Sub: Submissions of NTPC on Draft Central Electricity Regulatory Commission (Ancillary Services) Regulations, 2021.

NTPC's Submissions on
Draft (Ancillary Services) Regulations 2021

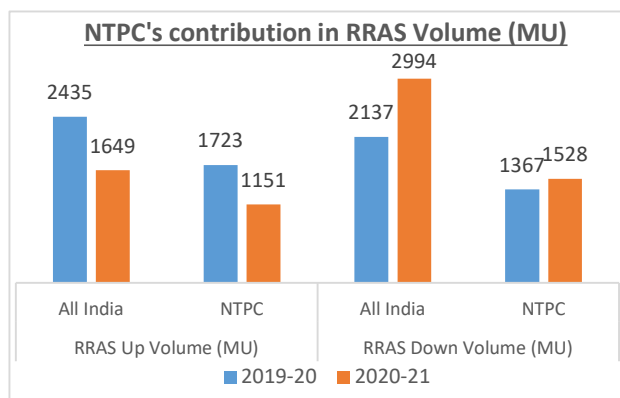
NTPC on its part has been at the forefront of providing Ancillary Services support in the country. As shown in the adjacent figure NTPC has been contributing nearly 70% of the total RRAS requirement of the Indian Grid. As a stakeholder of the Power Sector, it is also important for us to see that the Power System of the country is operated in a reliable and secure manner. It is our submission that the proposed mechanism should allow continuous participation of NTPC and other CPSUs for providing Ancillary Services.

8.0 Annexure: Barh U#4 & U#5 Graphs for RGMO Vs AGC Corrections

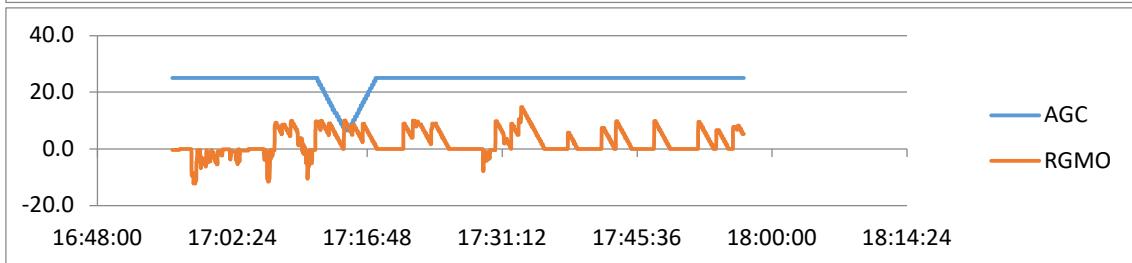
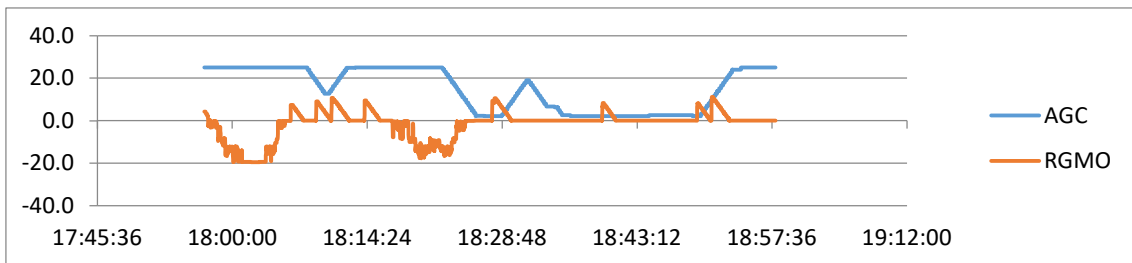
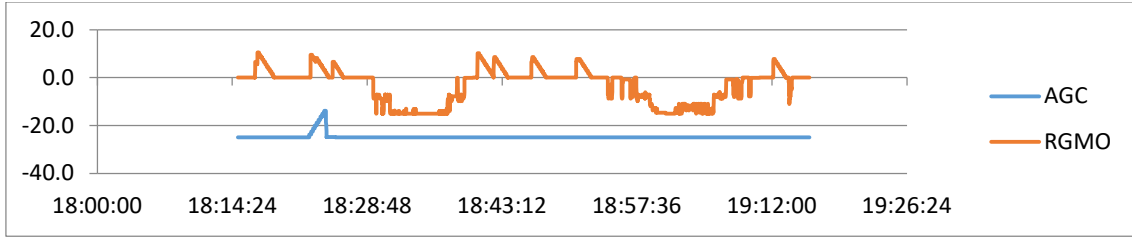
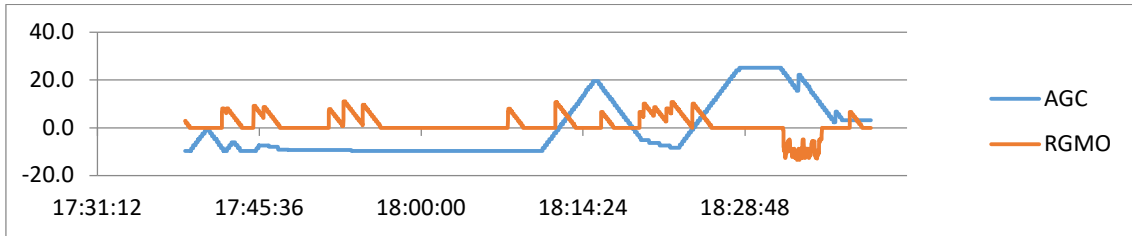
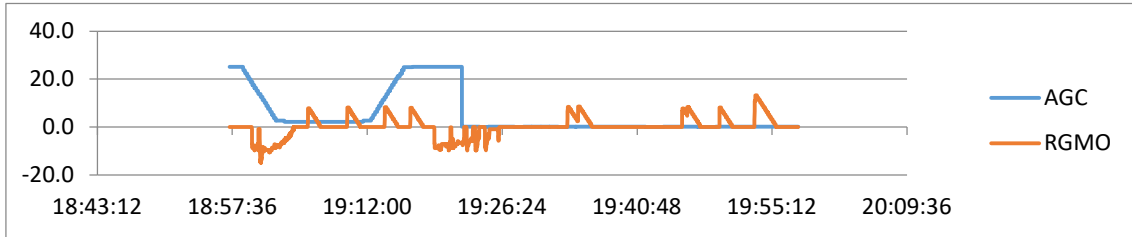
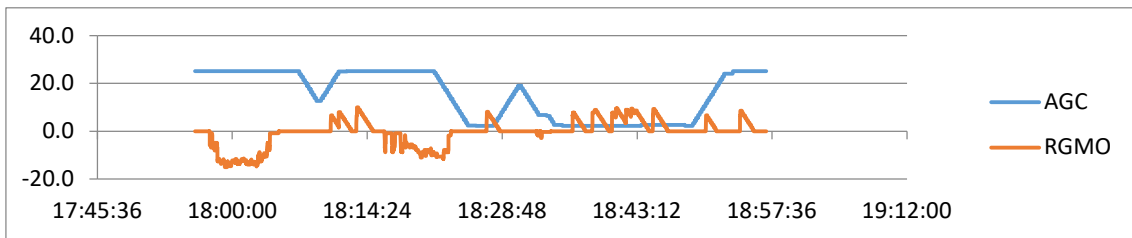
- After the rollout of Pilot AGC in five NTPC stations, it has been observed that at times RGMO correction and AGC correction sent by POSOCO can be opposite to each other, negating each other's correction. This is because RGMO is triggered by variation in frequency, while SRAS is triggered by ACE taking in account both frequency variations and the regional power interchange. In such a case, station would appear to be delivering inadequate response at both fronts during assessment by Nodal agencies. This needs to be taken care in the assessment procedure. *(Sample response curves indicating opposite actions of RGMO/ AGC is attached at Annexure-1)*

Considering the difficulties above, a better and error free approach for measurement performance against the SRAS signals may be explored. Currently the mark-up of 50 paise is linked to the AGC signal. Since the performance measurement concept is being introduced for the first time, it may be more appropriate to devise the incentive table based on the actual data of the SRAS providers for a period of 6 months.

It is also submitted that till such time, the existing practice of mark-up of 50 paise for AGC response may be continued.
